Conrail Speed Message

Subject: INTERMODAL FACILITY, COLUMBUS, OHIO
— FRAME TO WALL CONNECTION DETAILS

Date: APRIL 21 1986

ATTACHED ARE THE REMAINING DETAILS (4 SHEETS),
TO GO WITH DETAILS SUBMITTED 4-18-86. THESE
~~ARE~~ 4 SHEETS ARE FOR THE CONNECTION BETWEEN
FRAME 10 AND THE SOUTH ENDWALL.

ELEVATION - FRAME 10

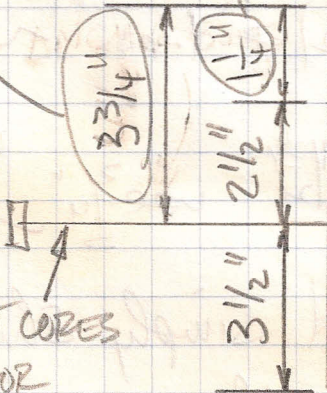
CONTRACTOR TO VERIFY THAT
 RURUN WILL NOT CONTACT
 WINDOW COLUMN IF IT
 DEPARTS 3" VERTICALLY
 DOWNWARD (TYP. BOLT COLS.)

SECT. A-A

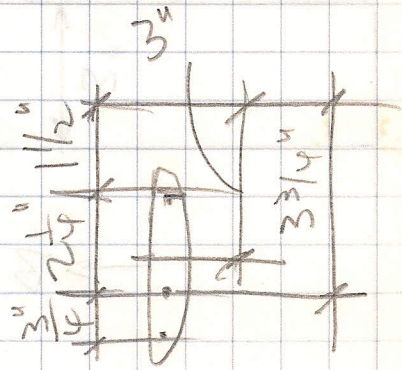
CHANGED FROM
4 1/2" JFM

CHANGED FROM 2" JFM

3, 5/8" A325 HS BOLTS, 2" LONG
(FIELD DRILL HOLES
IN RAFTER
FLANGE)

SECT. B-B

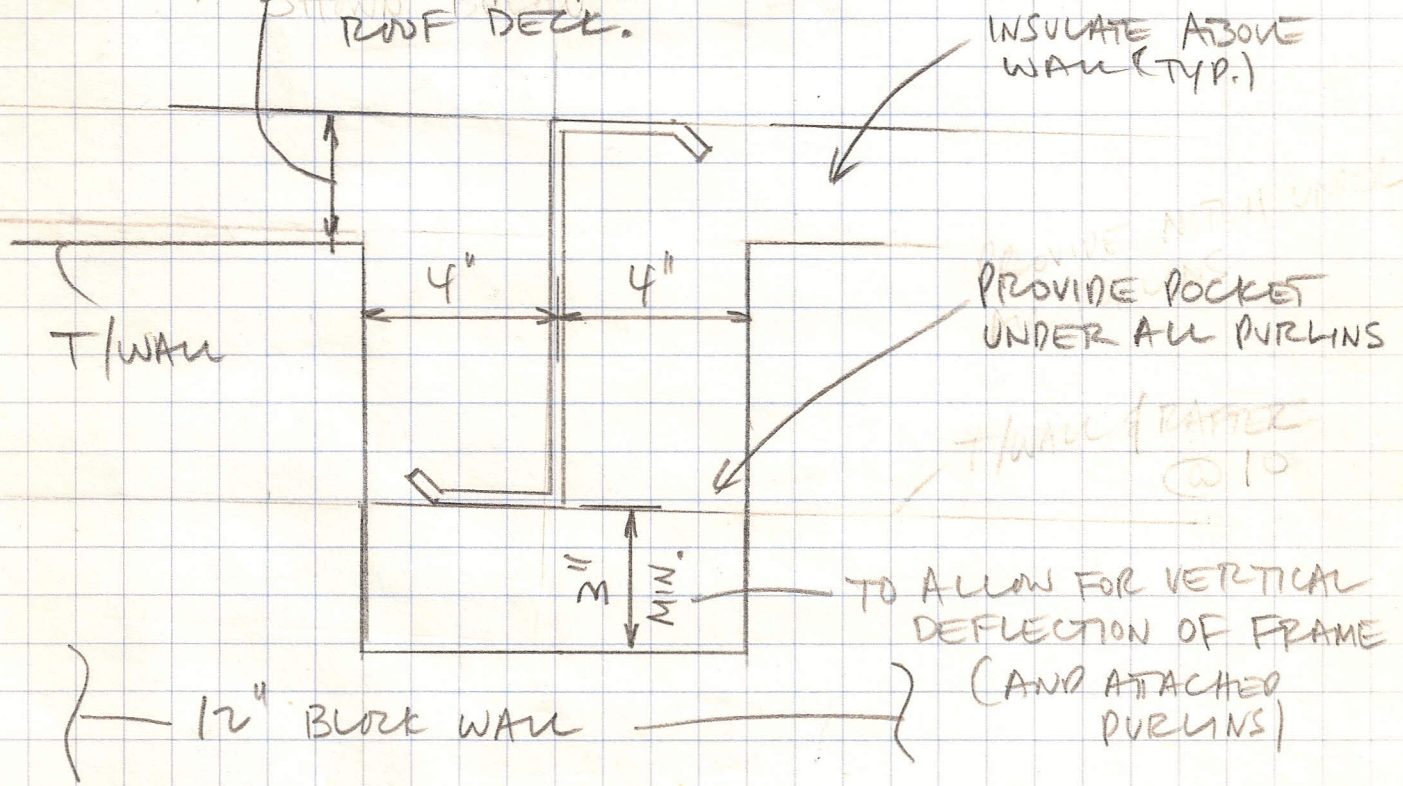
DEFLECTIONS as per Bill Perry, 5-6-86
 (over the
 phase)

Looking at south endwall from outside
 Starting @ right side (COL. LINE A)

12' in \rightarrow 1.59" down } includes crane
 21' in \rightarrow 2.57" down }
 ridge \rightarrow 2.56"

From left side (COL. LINE D)

12' in \rightarrow .82" down
 21' in \rightarrow 2.06" "

Max. upward defl. (@ ridge) = .9"

— need deflectors @ \sim 18' from right side

Downward $\sim .82 + \left(\frac{6}{9}\right)(2.06 - .82) = 1.65" \sim \underline{\underline{1\ 3/4"}}$ ✓

Upward $\sim \left(\frac{18}{30}\right) \cdot .9 = .54" \sim \frac{1}{2}"$ use $\underline{\underline{3/4"}}$ ✓

\therefore Can easily use 3" slot and simply shift location of anchor bolt in wall.

NOTE: LOWER GABLE ANGLE MUST BE USED TO ALLOW FLASHING TO MEET WITH FLARE AND BE SET INTO HORIZONTAL LEG OF THE CHANNEL. KEEP TOP OF WALL A MIN. OF 3" AND MAX. OF 5" BELOW ROOF DECK.
